SERVICE

X 96.005-26

Model 225

Filter cover

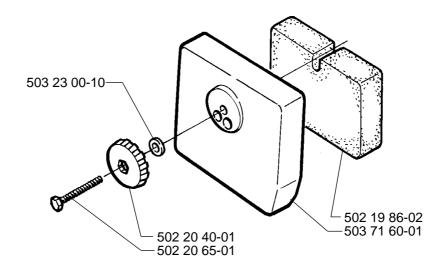
Two holes have been introduced into the filter cover to improve the air flow through the air filter. Washer 503 23 00-10 has been added to create a gap between the knob and the filter cover. This washer will soon be superseded by a spacer integrated into the filter cover.
